গণপ্রজাতন্ত্রী বাংলাদেশ সরকার  
শ্রম ও কর্মসংস্থান মন্ত্রণালয়  
কলকারখানা ও প্রতিষ্ঠান পরিদর্শন অধিদপ্তর

ক্যাপ পর্যবেক্ষণের তথ্য

কারখানার নাম	এ্যাংগোরা মোটোরস লিঃ
ঠিকানা	79-B, Malibagh Chowdhury Para, Dhaka
কারখানার কোড	DHK047
কালার কোড	
মূল্যায়নের ধরণ: <a href="#">কাঠামোগত মূল্যায়ন</a>	পর্যবেক্ষণের তারিখ: ০৩-০৪-২০২৩
১. পর্যবেক্ষণ

পরিদর্শন পর্ববেক্ষণ	Crack and Dampness
কাপ আইটেম ক্যাটাগরি

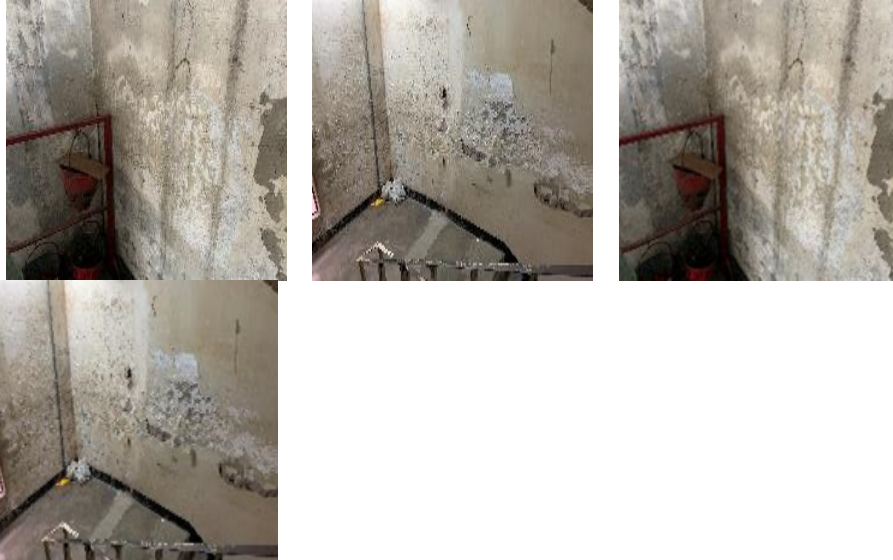
কার্যক্রম	Cracked and partially damaged net cement finished topping in floors and stair cases of the building shall be repaired by adopting appropriate method for both aesthetic and serviceability requirements.
সুপারিশের তথ্যসূত্র	
কারখানার কার্যক্রম	Action has been taken
অগ্রাধিকার	প্রয়োজ্য নয়
চূড়ান্ত সময়সীমা	১২-০৯-২০১৬
সংশোধিত সময়সীমা	০১-০১-১৯৭০
অগ্রগতির অবস্থা	শুরু হয়নি
মন্তব্য	20.09.2020: Crack and partially damaged net cements finished topping on floor and stair cases. Some places repair. It is ongoing process. 10/12/2020: Dampness found mostly on toilet areas walls which are mostly observed in the stair cases. They should be checked by an engineer and corrected properly. 07/06/2021: Dampness found mostly on toilet areas walls which are mostly observed in the stair cases. The factory management is now saying that they will solve this issue within one month. 22.08.2021: Dampness found mostly on toilet areas walls which are mostly observed in the stair cases. The factory management is now saying that they will solve this issue within one month. 01/08/2022: Cracks and dampness were found in the stair cases on the date of inspection. 03/04/2023: Cracks and dampness were found in the stair cases on the date of inspection.
